ORCHARD GARDENS REDEVELOPMENT

DEVELOPMENT FOR:  
FIRST COMMUNITY HOUSING  
245 W.WEDDELL DRIVE, SUNNYVALE, CA 94089

100%  
CONSTRUCTION  
DOCUMENTS &  
PERMIT SUBMITTAL  
ISSUED ON:  
07.14.2025

Misc. Plan  
Permit -  
Substantial  
Conformance  
Documentation

SECOND FLOOR PLAN

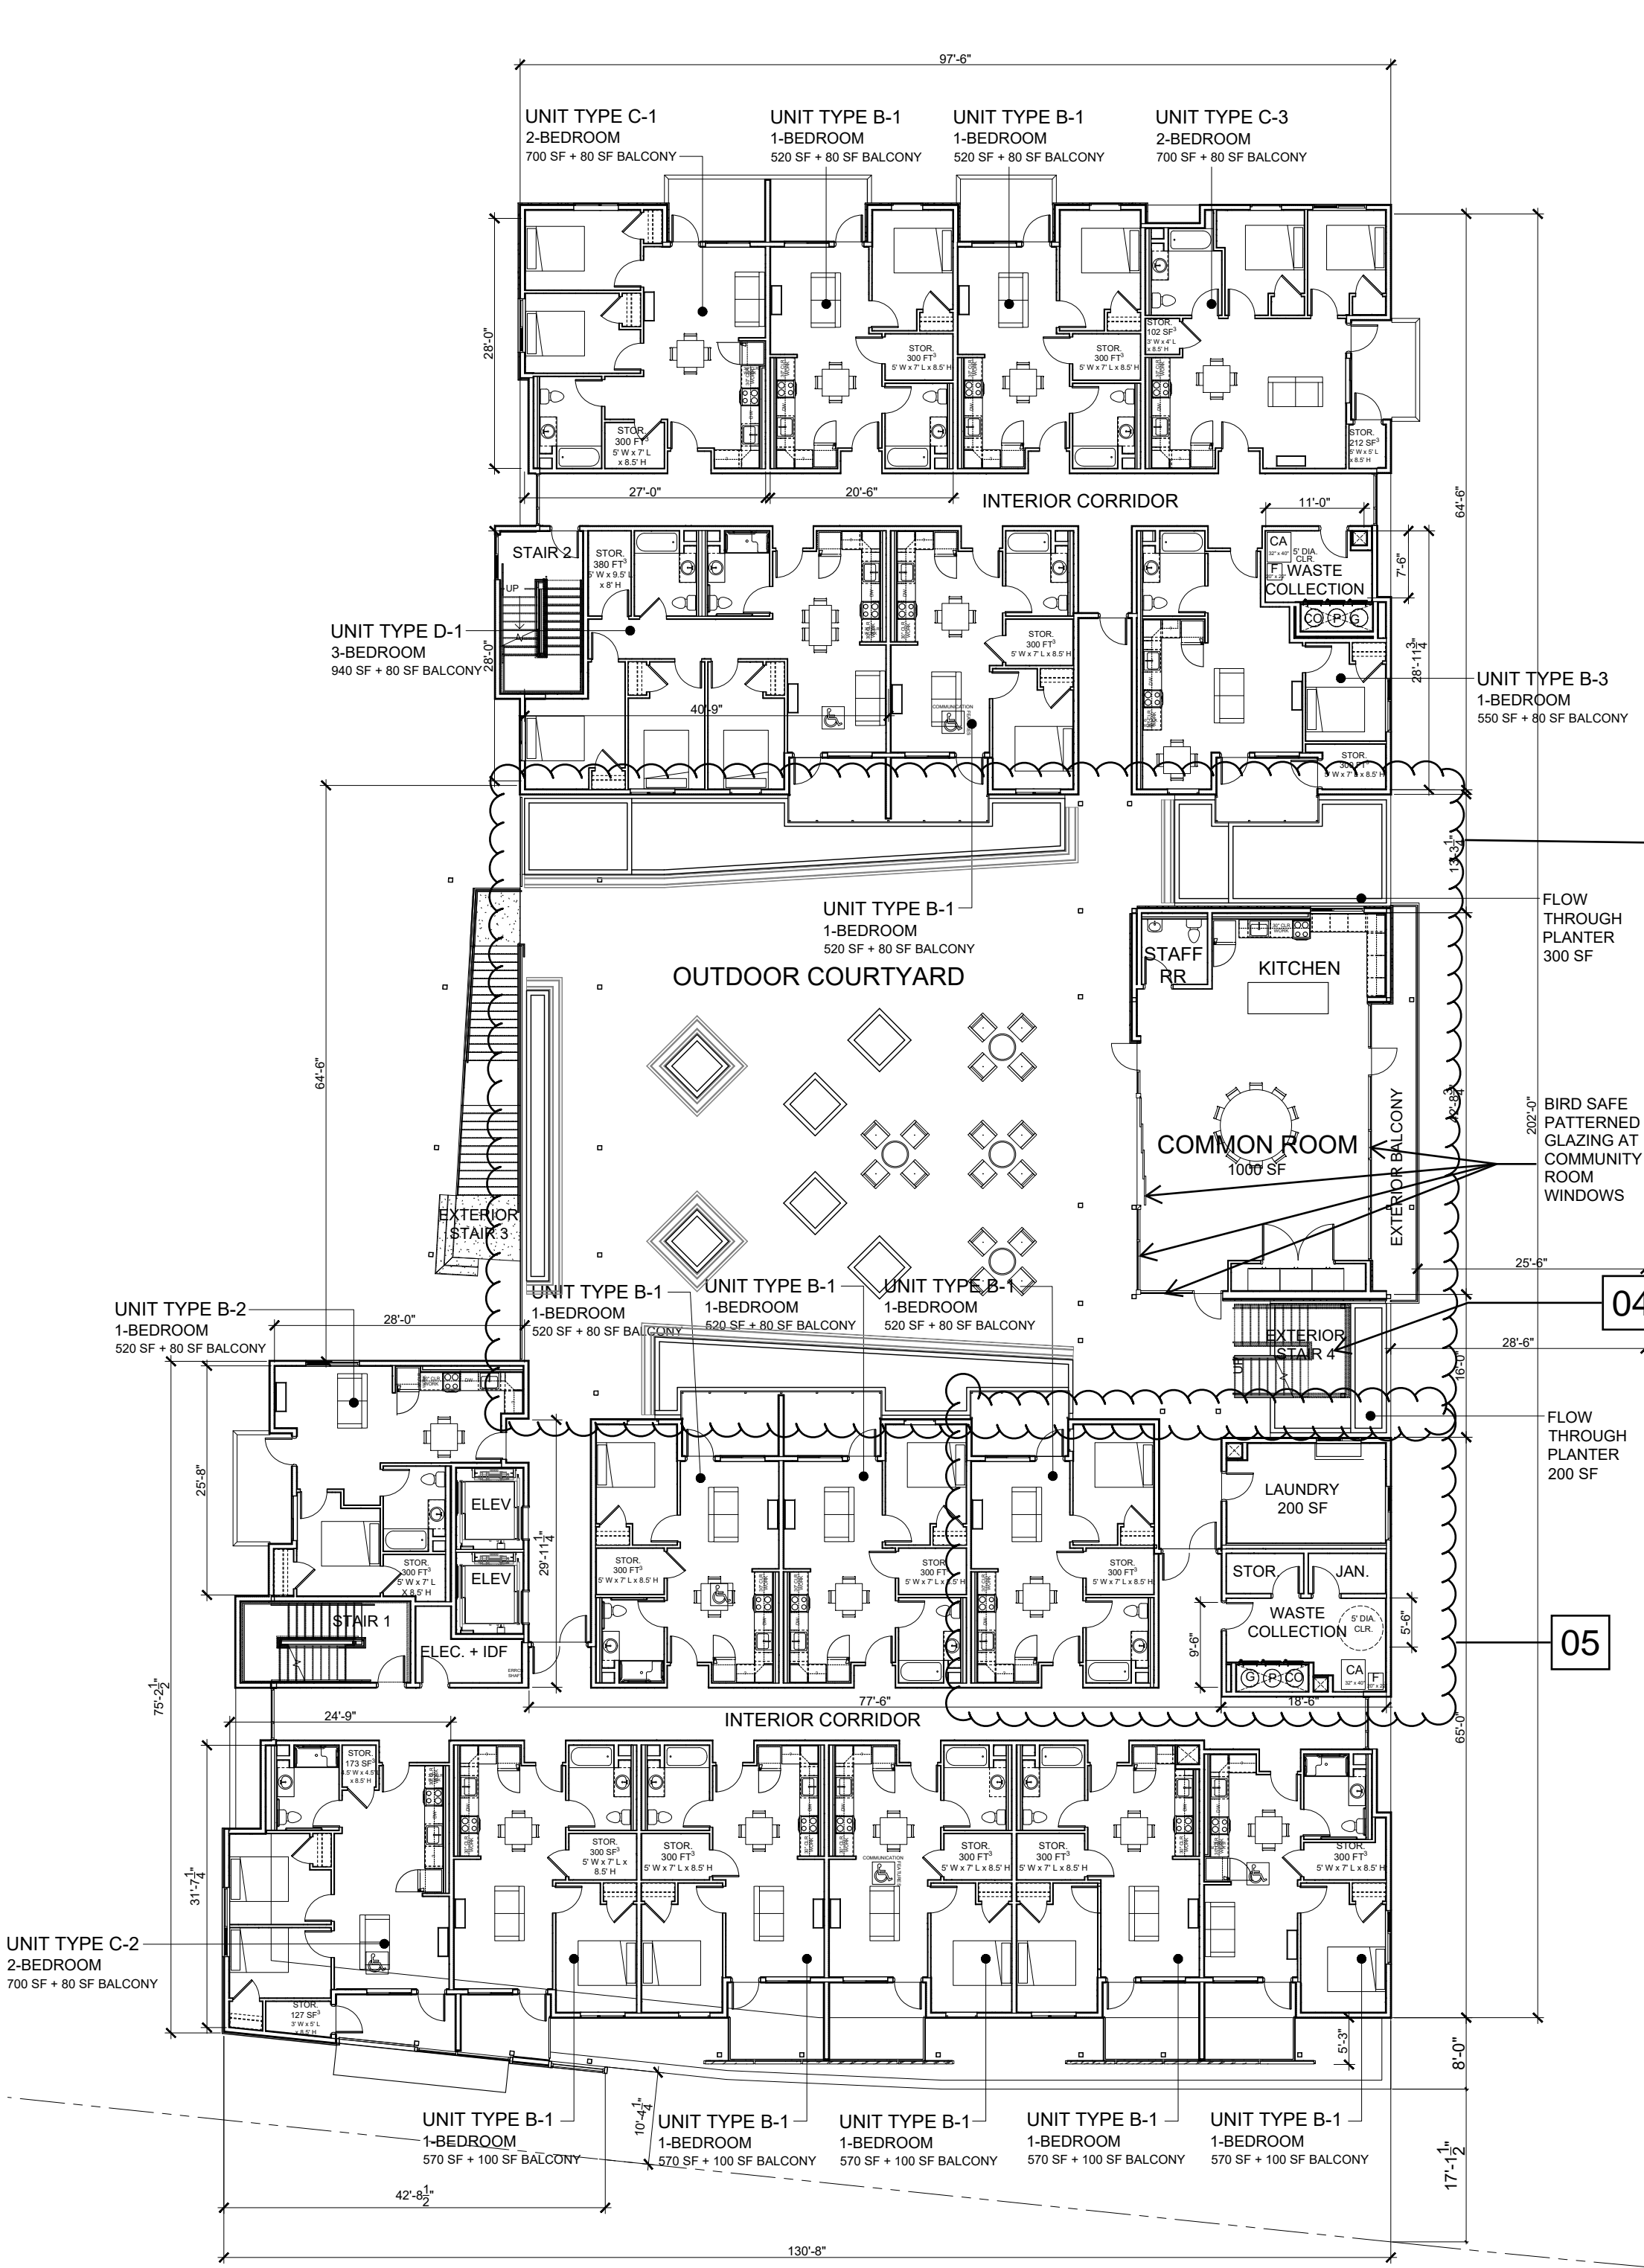
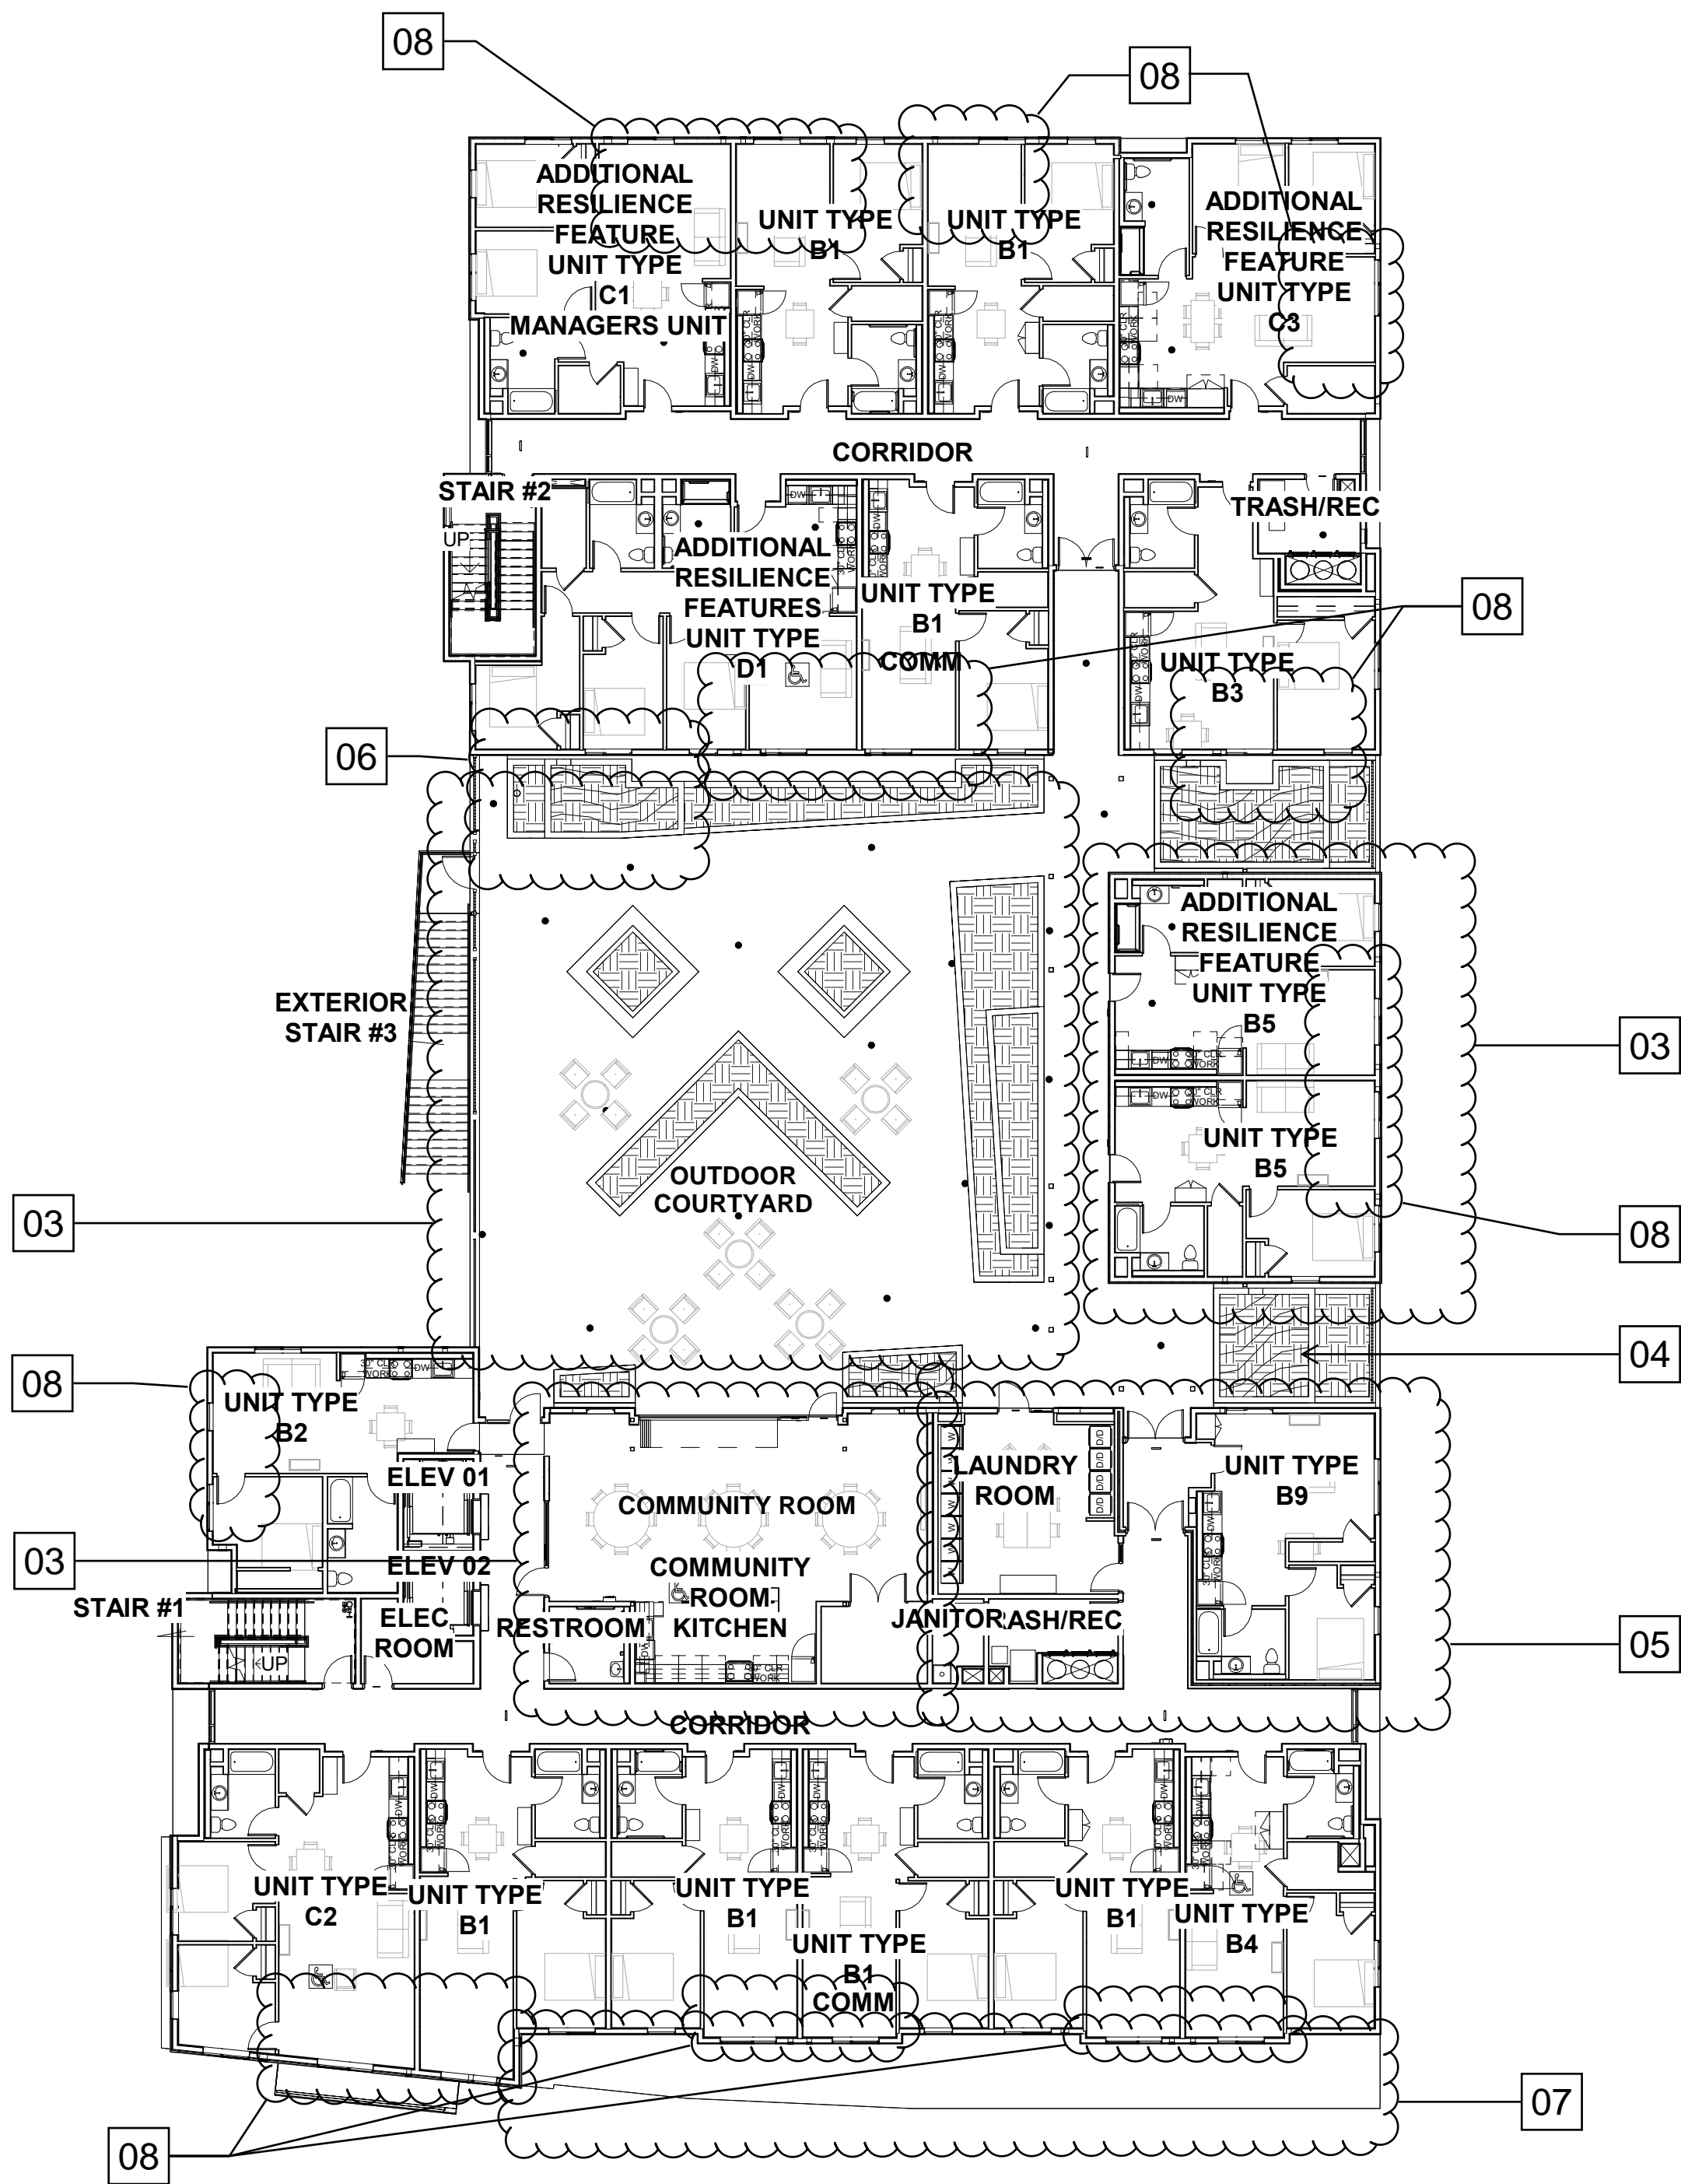
- 09REMOVAL OF SOUTHERN SCREEN WALLS AND BALCONIES.
- 10\*ROOFTOP EQUIPMENT SCREEN REVISED TO SOLID WALL, NOT VISIBLE FROM STREET.
- 11\*HIGHEST SLOPED PORTION OF THE ROOF RAISED TO 75'-5" ALONG THE EAST SIDE OF BUILDING
- 12REPLACE CENTRALIZED VRF SYSTEM WITH PTHP, PROVIDE NECESSARY LOUVERS
- 13PLANTER WALL MATERIAL AT FRONT ELEVATION CHANGED FROM WOOD BOARD OVER CONCRETE TO CMU

SOUTH ELEVATION (STREET ELEVATION) - MISC. PLANNING PERMIT ADJUSTMENT DRAWING

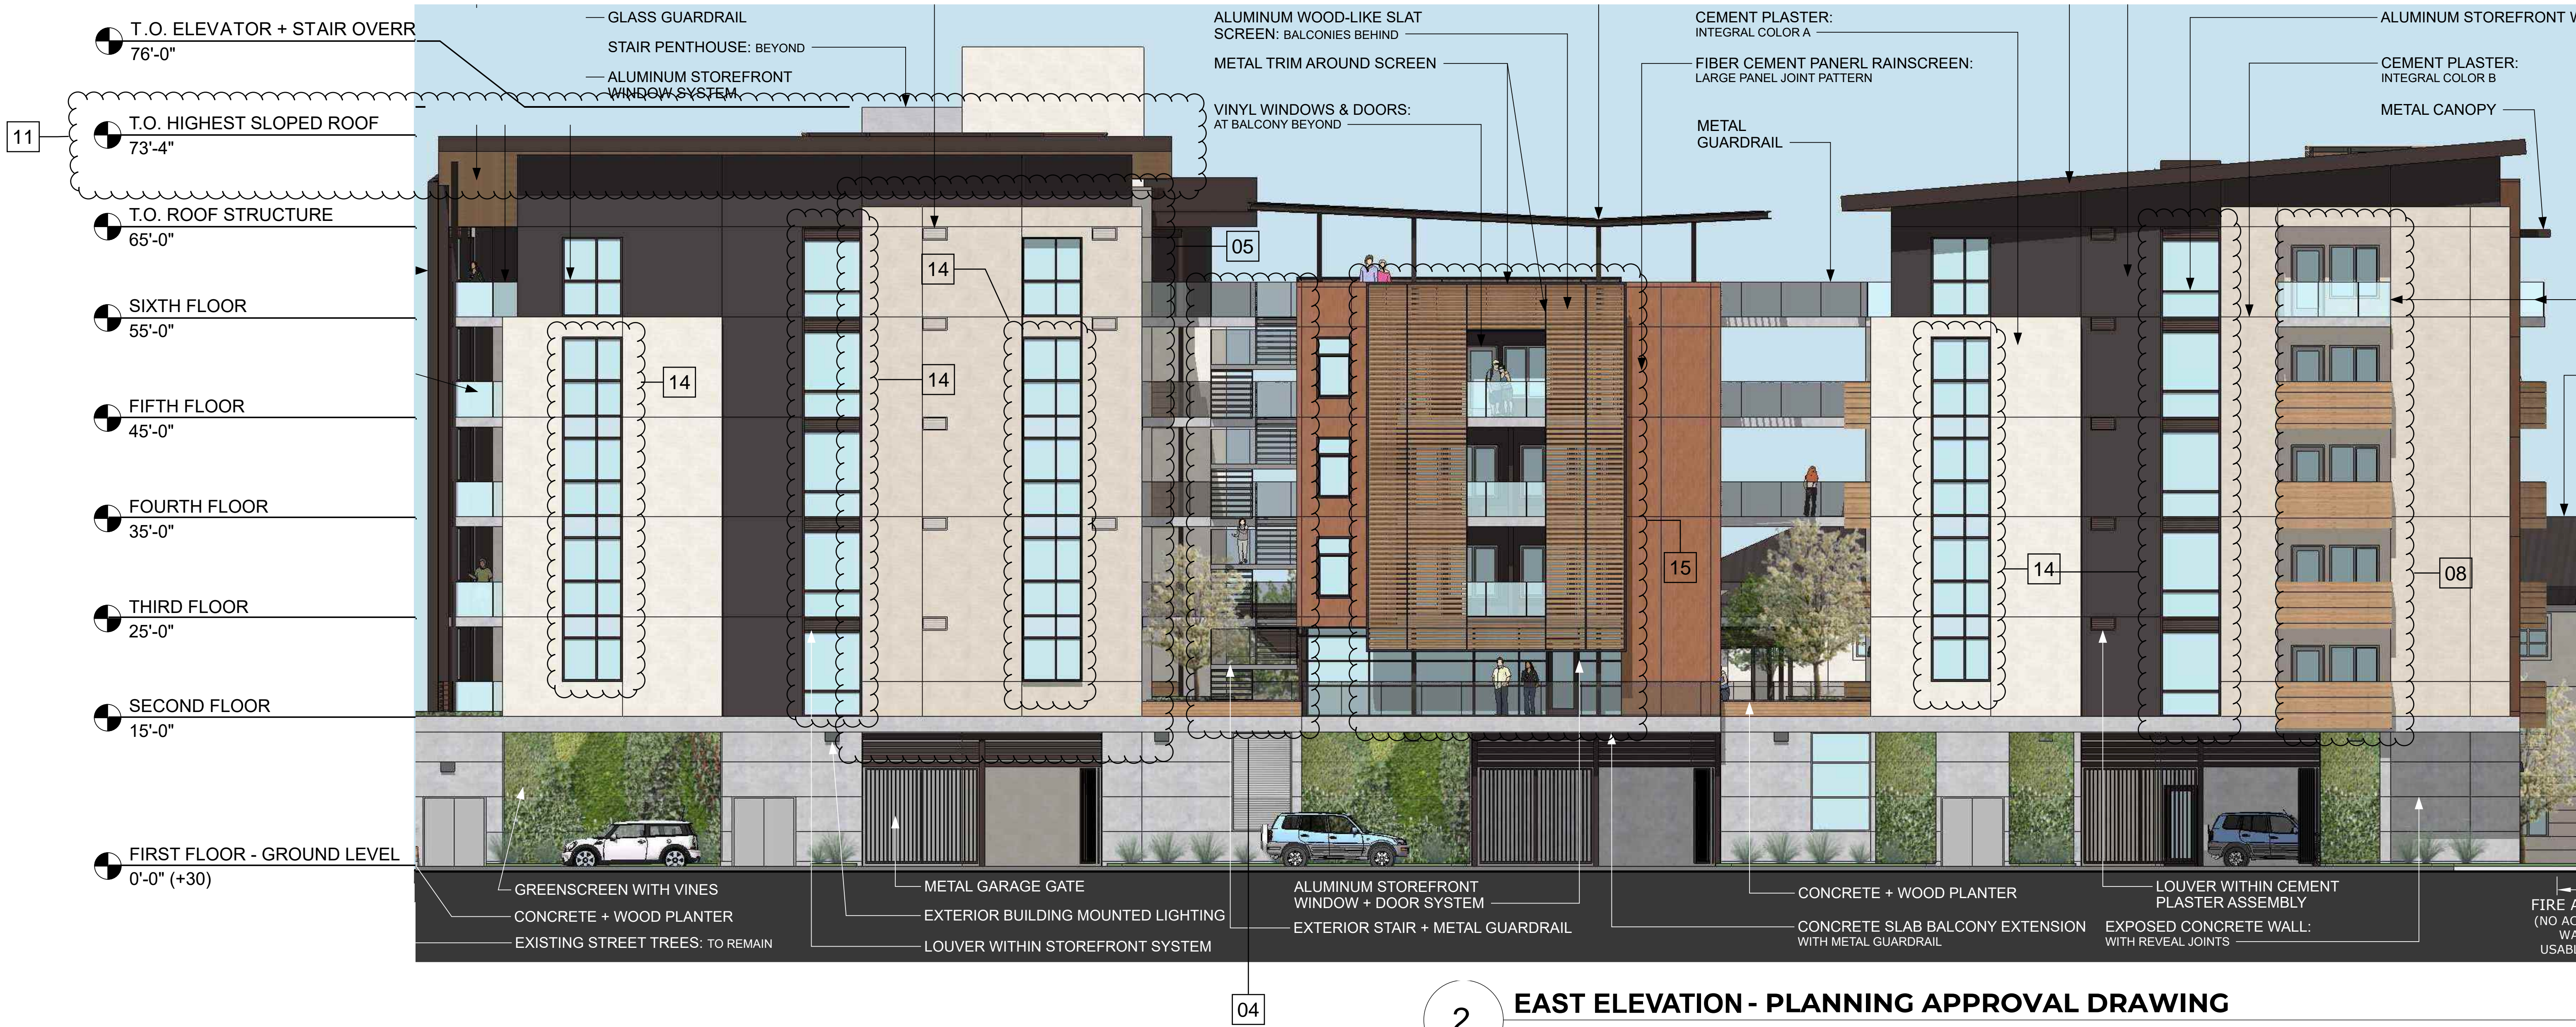
- 04 \*EXTERIOR STAIR 04 REMOVED. ENLARGED RAISED PLANTERS IN PLACE.
- 05 \*BUILDING A COMMON ROOM AND RESIDENTIAL UNIT STACK SWAPPED
- 08 REMOVED ALL BALCONIES.
- 11 \*HIGHEST SLOPED PORTION OF THE ROOF RAISED TO 75'-5" ALONG THE EAST SIDE OF BUILDING
- 12 REPLACE CENTRALIZED VRF SYSTEM WITH PTHP, PROVIDE NECESSARY LOUVERS
- 14 REPLACE STOREFRONT AND WINDOW WALL WITH PUNCHED OPENINGS
- 15 BUILDING B1 EXTERIOR FACADE UPDATED TO REFLECT COMMON ROOM RELOCATION.
- \*STARRED ITEMS WERE PART OF THE PREVIOUSLY REVIEWED MPP SET, REVIEWED AUGUST 2022
